Docket Item # 5 BAR CASE # 2009-0147

BAR Meeting July 29, 2009

**ISSUE:** Alterations

**LOCATION:** 1600 King Street

Figure 1: Site Plan showing proposed location of new walk-in-cooler.

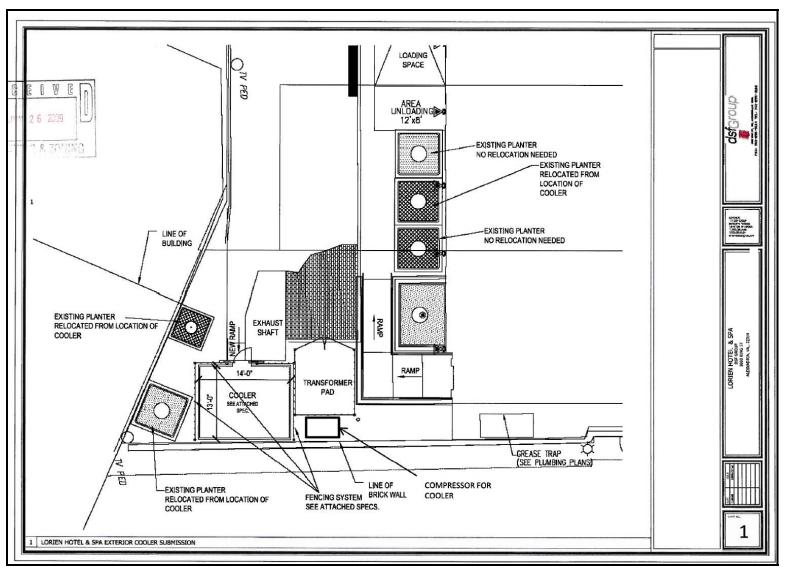
The applicant is requesting approval of a Certificate of Appropriateness to locate a walk-in-cooler structure to the rear of the new Lorien Hotel and Spa at 1600 King Street. The new walk-in-cooler will be located in current rear service area, next to an existing transformer and large concrete planters, and adjacent to the rear service entrance into the restaurant kitchen. Two existing planters will be relocated within the area in order to install the cooler. The cooler will be 14 feet x 13 feet in size, and will be screened using the same fencing system as the existing transformer. The fencing is a welded steel ornamental fence manufactured by Ameristar in the Montage II model. The fence consists of black metal pickets and will be 7 feet six inches tall and will enclose the cooler on all sides. Two sliding gates and a small ramp will provide access to the cooler from the alley area. The cooler itself is manufactured by Kolpack, in a Polar Pak System model. A compressor for the cooler will be located in the area behind the existing transformer pad, behind the existing brick wall.

Development Staff has reviewed the application and finds the proposal compliant with previous Development Special Use Permit (DSUP) conditions. The revisions to the site plan, such as the relocation of planters and addition of the cooler, screening, and access ramp, will be coordinated administratively through the minor amendment process.

Proposed cooler relocation/fence screening complies with zoning ordinance requirements.

Figure 2: Photographs of existing condition and proposed screening.

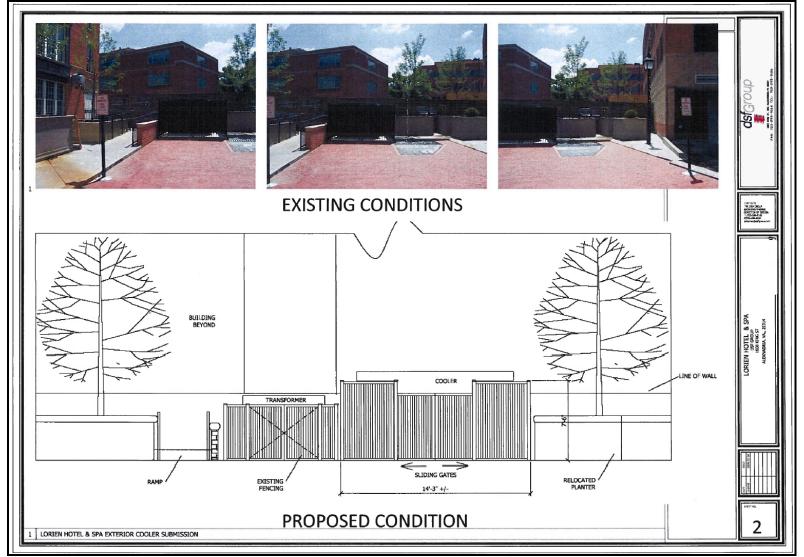
While the Design Guidelines do not directly address items such as coolers, Staff finds that certain guidance can be derived from such items as exhaust and supply fans, HVAC equipment, and fencing. According to the Guidelines, these features "...should not hide, obscure, or cause the removal of historic architectural details", "should not disrupt the architectural character of a structure," "should be located in visually inconspicuous sections of a building," and "fences should be appropriate in materials, design and scale to the period and character of the structure they surround." In Staff's opinion, the cooler and its screening meet this guidance and are appropriate for this early 21<sup>st</sup>-Century building. By locating the cooler away from the building, in an area that is already designated for service and utility functions, the cooler and its screening will not impact the design and architectural integrity of the building, not impact any historic buildings. Therefore, Staff recommends approval of the application as submitted, noting the standard recommendations from Alexandria Archaeology.
